**HUME COAL PROJECT SSD 7172 IPC HEARING – MOSSVALE 27TH FEBRUARY 2019****INTRODUCTION**

John Lee is my name, I am a hydrogeologist with extensive experience in a number of geoscientific fields. I represent and support the landholders and particularly the *Water Access License* (WAL) holders in the region potentially affected by the mining proposal. I have worked in the region for over 25 years on several hundred private projects and have been closely involved in developing a clear understanding of the geological and hydrogeological controls of groundwater over a wide area.

HYDROGEOLOGY & AQUIFER DISTRIBUTION IN ROSEDALE BORE

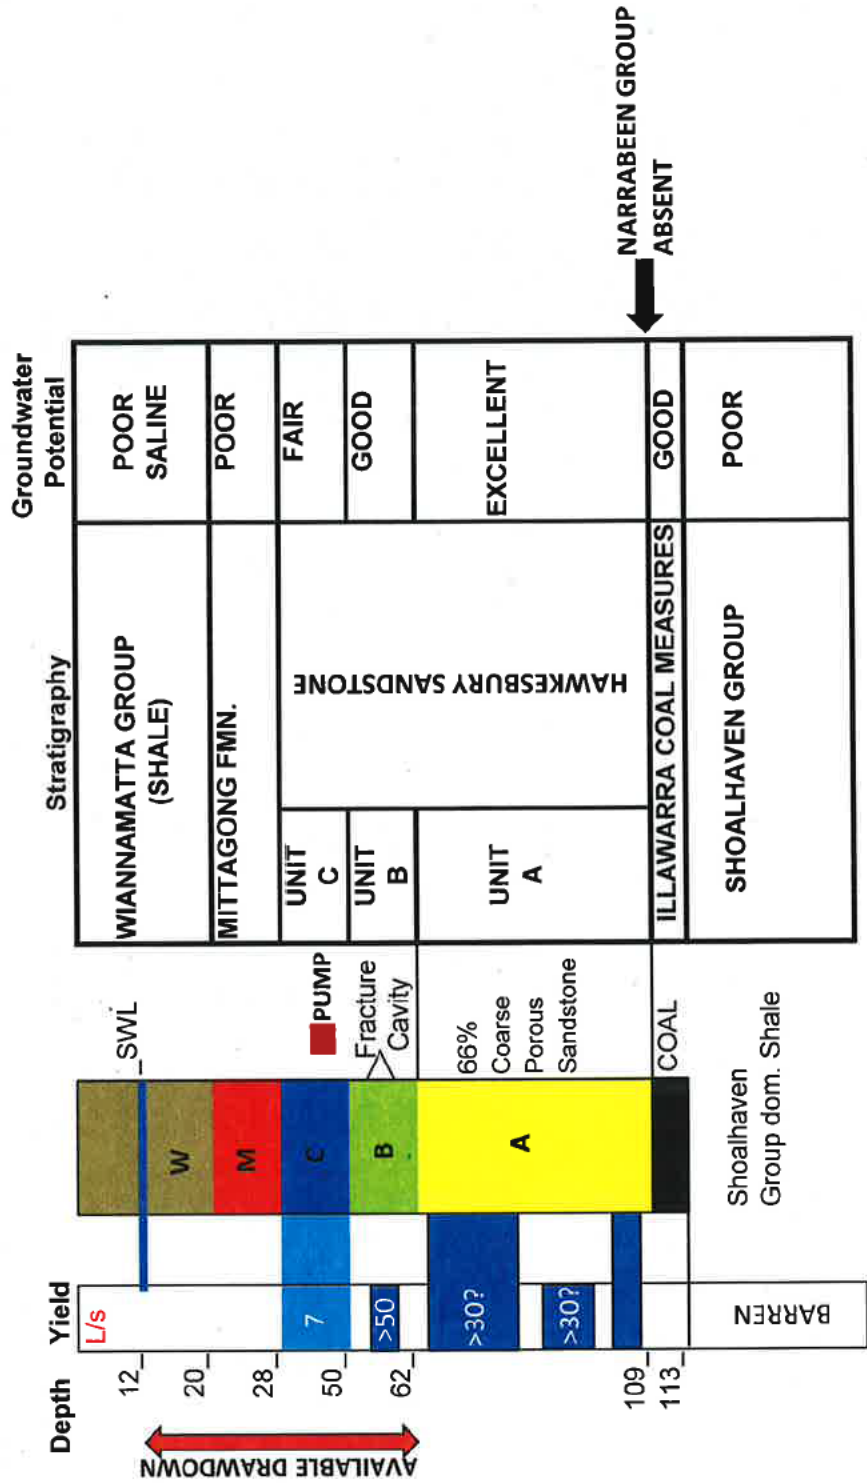
SLIDE 3. The Rosedale bore has been used to illustrate the local stratigraphy, and shows the Wianamatta Group, Hawkesbury Sandstone, Illawarra Coal Measures and Shoalhaven Group sequences in relation to groundwater occurrence.

The bore provides an excellent example of a bore that was targeted within an interpreted fracture zone, with groundwater associated with both primary and secondary porosity. The bore was tested at a maximum pump rate of 42 L/s, associated with a 24-hour drawdown of only 8.68m below the SWL of 12.8m. The ultimate capacity of the bore is in the range of 50-100 L/s.

SLIDE 2

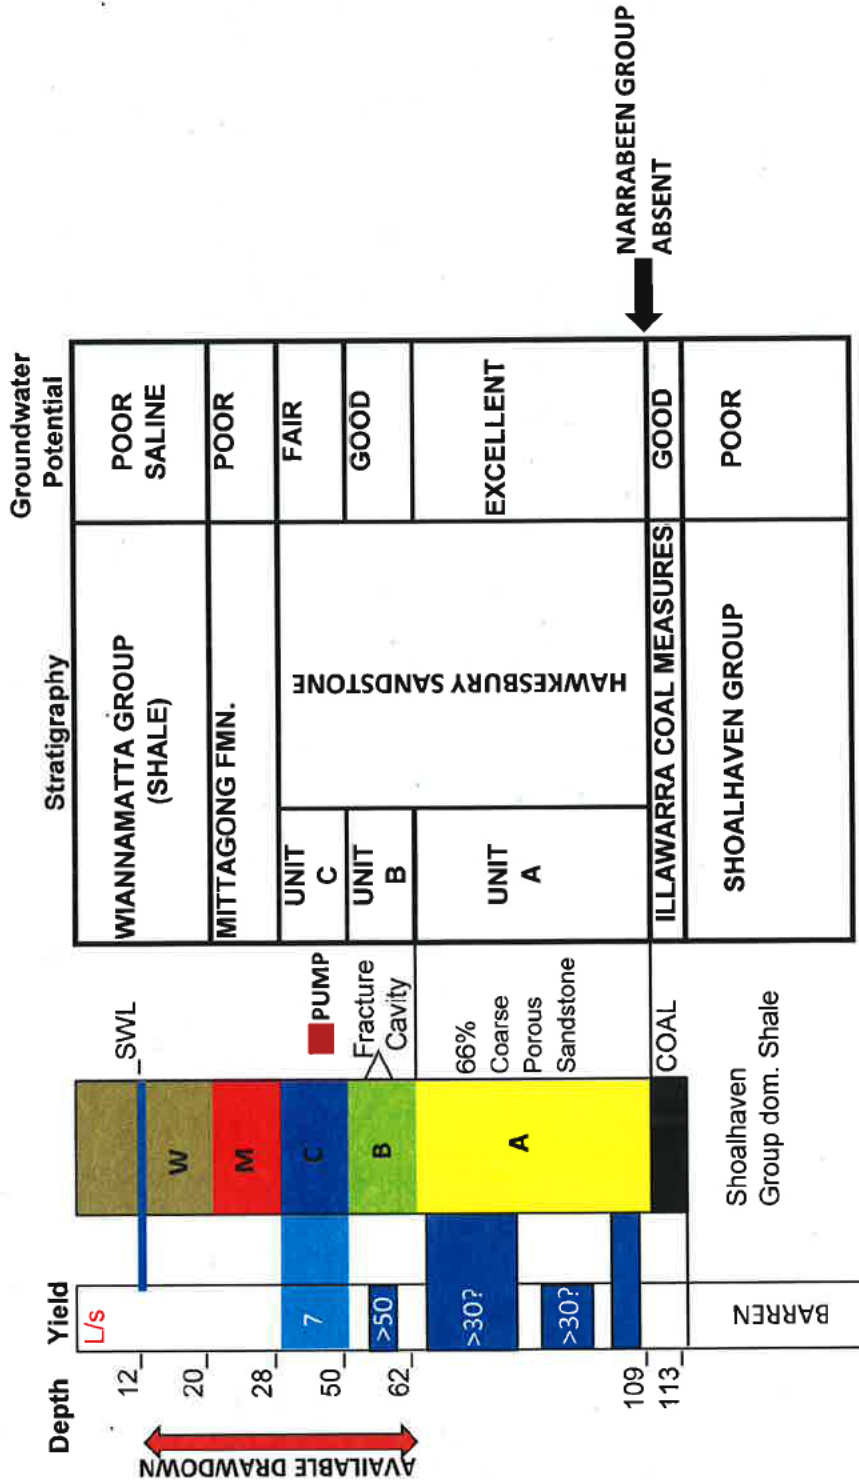
SLIDE 2 shows the flow of water during testing operations in 2005 at 42 L/s flow. We can make a few valid comments about the principal occurrences and controls of groundwater in the region.

SLIDE 7

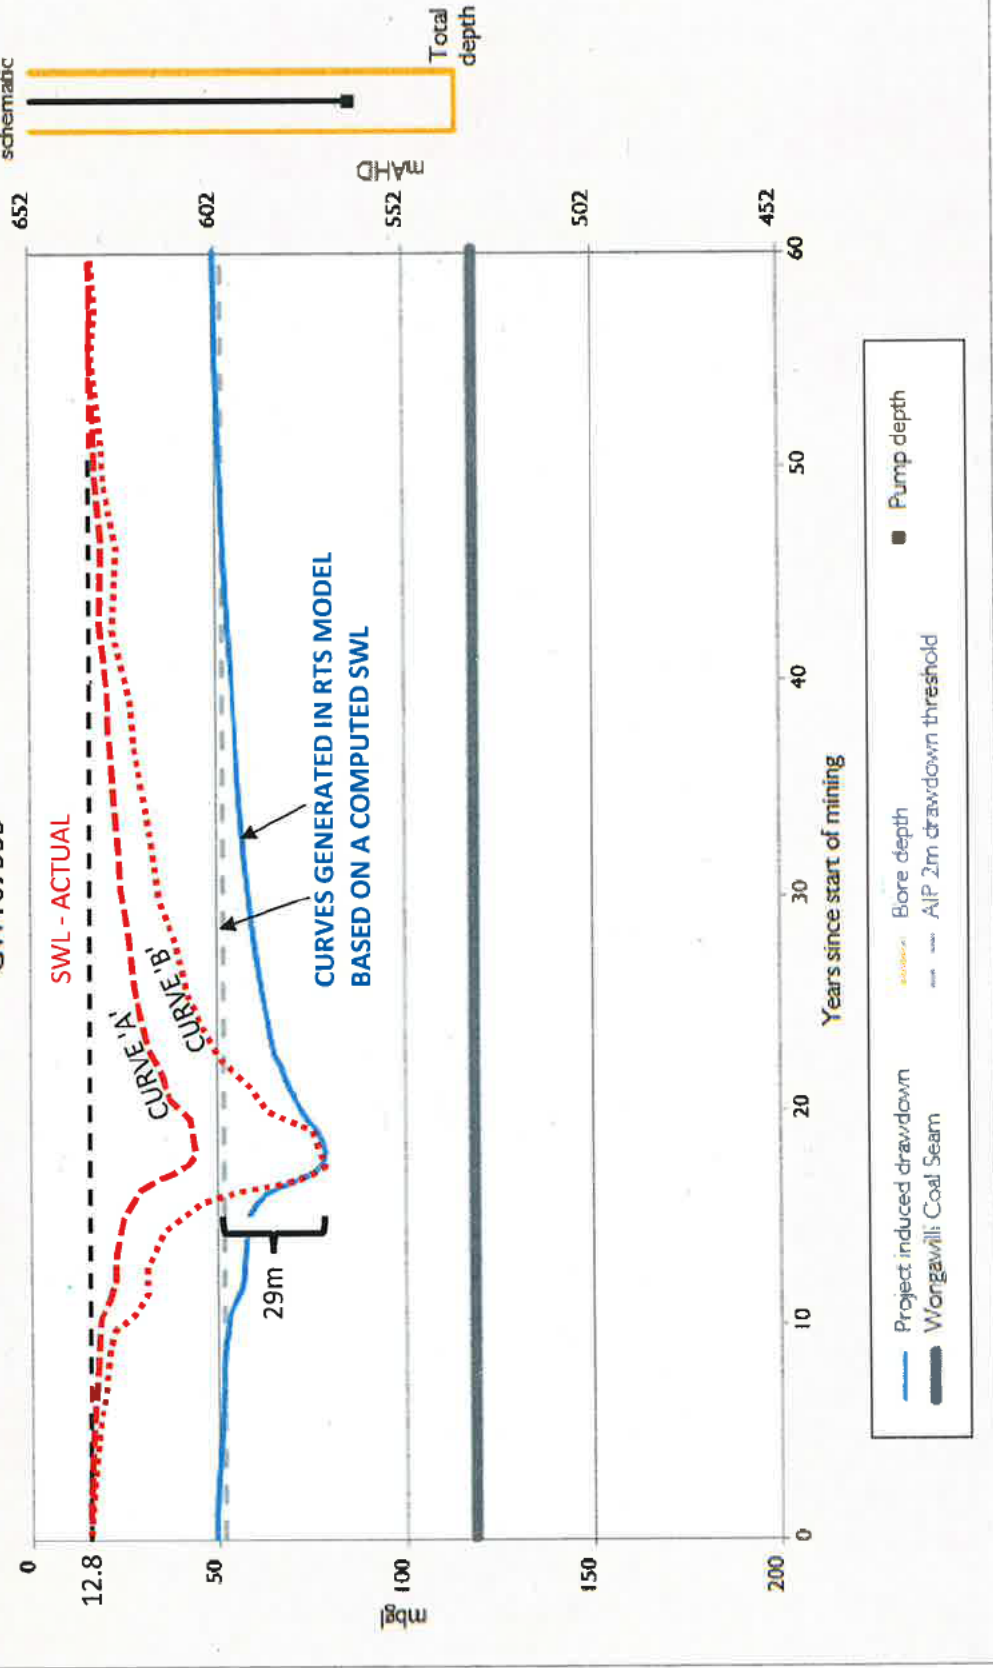
SLIDE 7 shows the relative variance between the computed and realistic SWL's. The data manipulation has been adopted in all bores affected. Of note is that the Rosedale bore is still operating as designed. The Comfort Hill bore has an apparent reduction in water level by only approximately 2m since 2005, at a time of 'drought'. This relationship is believed to exist throughout the region.

Hydroillex Pty Ltd www.hydroillex.com.au	ROSEDALE BORE	
	UTM: - Jan-19	Hume Coal Hydrograph - Rosedale Bore
	Drawn: RJL Approved: RJL	SLIDE 8

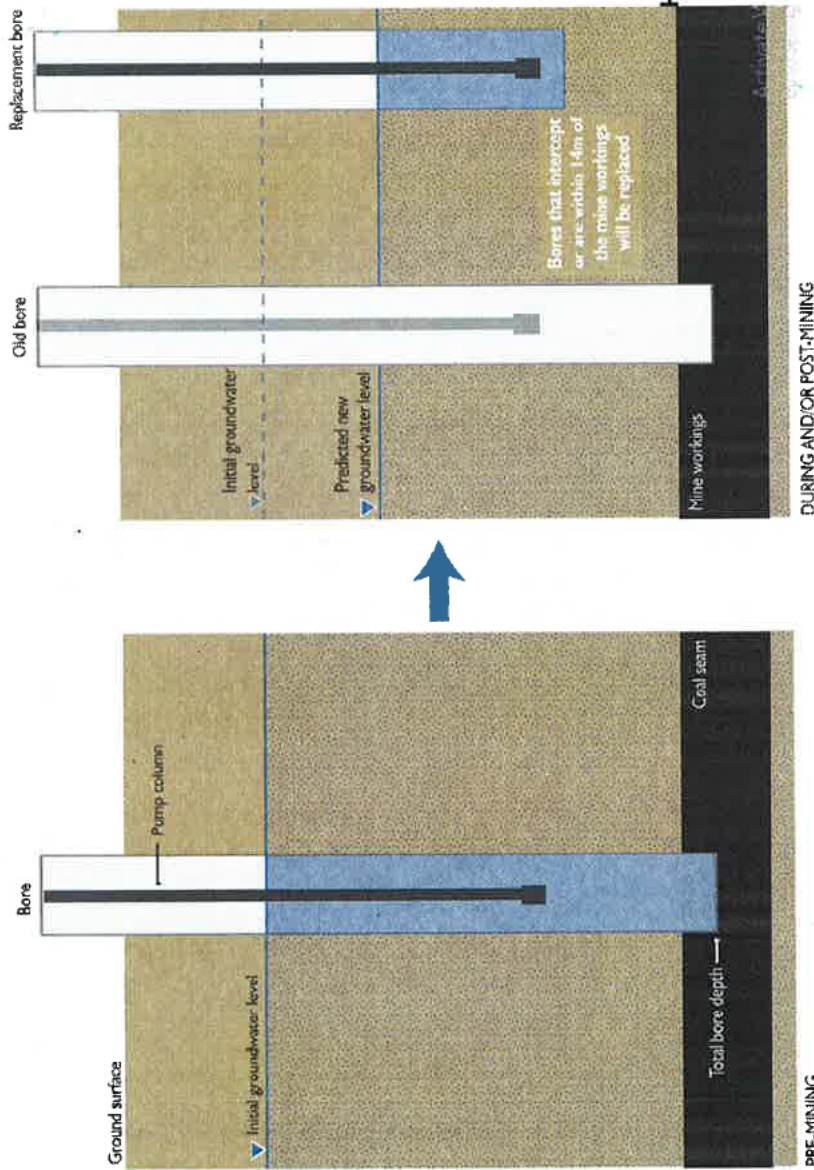
SLIDE 8 shows a hydrograph of the Rosedale bore, showing the likely drawdown curve, as predicted in the model. By creating an artificial 'initial standing water level', the impacts are reduced, and in the case of the example, the 2m AIP trigger is not initiated until the water level is reduced to ~53m. This is nonsensical!

HUME COAL GENERIC 'MAKE GOOD' CONSTRUCTION DIAGRAM FOR REPLACEMENT BORE

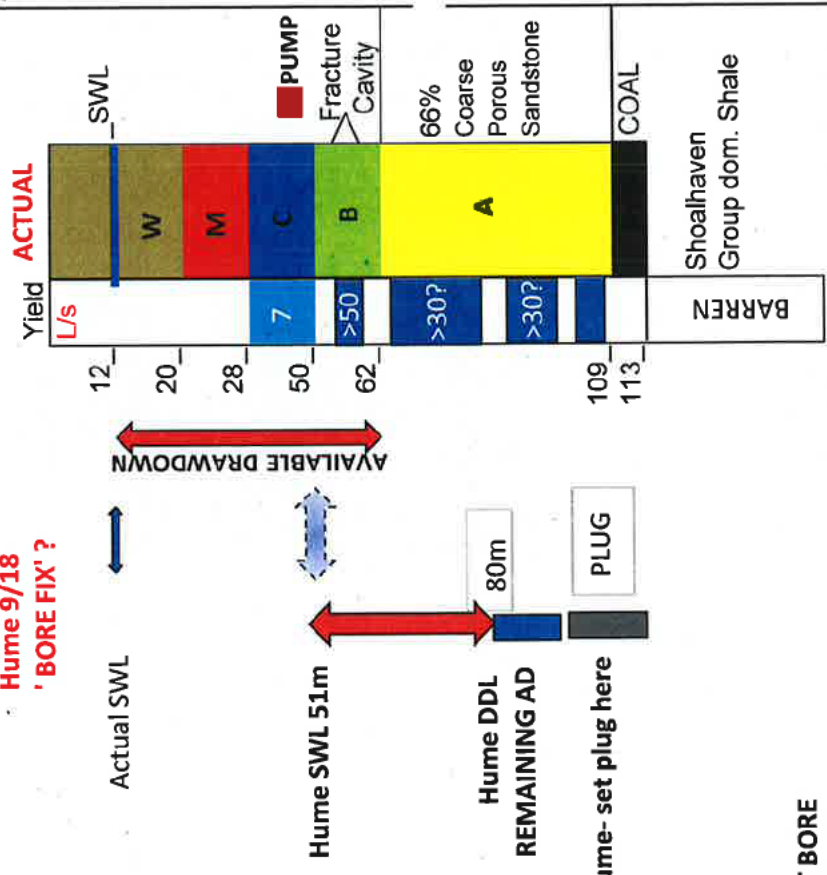
SLIDE 9 shows the proposed 'fix' for the Rosedale bore.

- Initially the bore was proposed to be deepened, but there is no significant water in the Shoalhaven Group.
- It is not feasible to relocate, as the yield may be reduced.
- It is now proposed that the lower part of the sandstone aquifer be sealed-off, but if the DDL of 80m is achieved, then there would only be ~10m sandstone aquifer head.

The following is proposed by Hume:

1. Reduce the depth of the bore by setting a plug at the base
2. Draw the water down to below the deepest level below 80m
3. This allows only about 10m of water column
